UNITED STATES PATENT AND TRADEMARK OFFICE

APPLICATION NO.	FILING DATE	FIRST NAMED INVENTOR	ATTORNEY DOCKET NO.	CONFIRMATION NO.
10/549,291	09/16/2005	Junko Iwanaga	071971-0361	8090
53080 7590 05/16/2008 MCDERMOTT WILL & EMERY LLP 600 13TH STREET, NW WASHINGTON, DC 20005-3096			EXAMINER LIN, JOHN	
			ART UNIT 2815	PAPER NUMBER
			MAIL DATE 05/16/2008	DELIVERY MODE PAPER

Office Action Summary

DETAILED ACTION

FIG. 10A

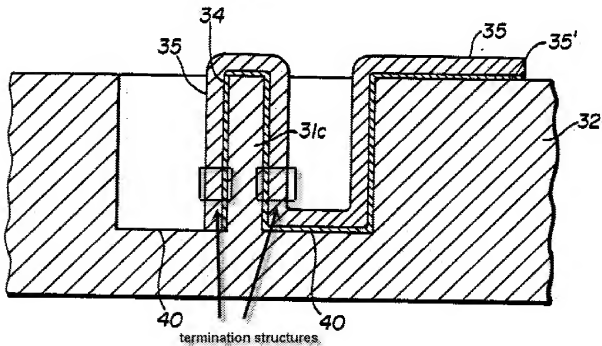
Claim 1: Shirasaki teaches a semiconductor device (Figs. 10 and 10A) comprising:

a semiconductor substrate (32) in which a trench (30) is formed;

a source region (31a) and a drain region (31b), each of which is buried in the trench and contains an impurity of the same conductive type;

a semiconductor FIN (31c) buried in the trench and provided between the source region and the drain region;

a gate insulating film (34) provided on both side surfaces of the semiconductor FIN as well as an upper surface of the semiconductor FIN; and

a gate electrode (35) extending over the semiconductor substrate extending from the upper surface of the semiconductor FIN toward both sides of the semiconductor FIN in the shape of a rod and formed directly on the gate insulating film,

wherein the gate electrode has in the trench, termination structures (see Fig. 10A below) extending toward a bottom of the trench along both sides of the semiconductor FIN (column 7, lines 35-67).

Claim 6: Shirasaki teaches a field-effect transistor (Figs. 10 and 10A) including a semiconductor substrate (32) in which a trench (30) is formed, a source region (31a) and a drain region (31b) each of which is buried in the trench and contains an impurity of the same conductive type, a semiconductor FIN (31c) buried in the trench and provided between the source region and the drain region, a gate insulating film (34) provided on a side surface of the semiconductor FIN as well as an upper surface of the semiconductor FIN, and a gate electrode extending over the semiconductor substrate from the upper surface of the semiconductor FIN toward both sides of the semiconductor FIN in the shape of a rod, and formed directly on the gate insulating film, wherein the gate electrode having in the trench, termination structures (see Fig. 10A

above) extending from the upper surface of the semiconductor FIN toward a bottom of the trench along both sides of the semiconductor FIN (column 7, lines 35-67).

Examiner notes that "the shape of a rod" is not defined in the specification. For the purpose of applying art, "the shape of a rod" will be interpreted as a thin straight of material. Shirasaki therefore teaches a gate electrode (35) extending over the semiconductor substrate (32) extending from the upper surface of the semiconductor FIN (31c) toward both sides of the semiconductor FIN in the shape of a rod (Figs. 10 and 10A; column 7, lines 35-67).
